21-129CP– 4012 W. DUBLIN-GRANVILLE ROAD

Summary

Construction of an approximately $\pm 14,000$ -square-foot, two-story, mixed-use building.

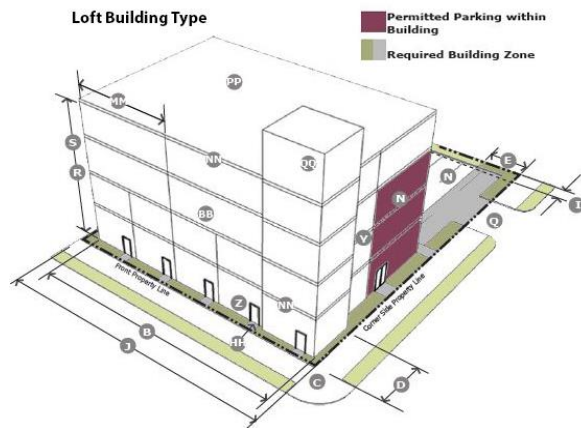
A rectilinear building is sited on the southern third of the site, fronting W. Dublin-Granville Road. An open space is proposed on the south edge of the building, fronting W. Dublin-Granville Road.

Parking is proposed to be provided in the northern two-thirds of the site located to the rear of the building. The site has one proposed full-access point from Banker Drive, which impacts the City-owned parcel which encompasses Banker Drive. The existing curb cut in the southeast corner of the site is proposed to be removed. A patio is located on the west edge of the building, with another patio centrally located on the rear of the building. Sidewalk access is proposed to extend along the David Road and Banker Drive frontages, where today there are currently no pedestrian facilities. Since the October 7, 2021 meeting, Planning and Engineering Staff have worked with the applicant regarding the improvements proposed within the City-owned parcel, and ultimately are supportive of the improvements as shown conceptually. With a Preliminary Development Plan, the applicant will be required to continue to work with Staff to ensure sidewalks and the curb cut are appropriately sited. There is an AEP easement along the eastern property line which limits building siting. A street wall will be required along the western edge of the parking area for screening, as the parking lot is within 20 feet of a public right-of-way.
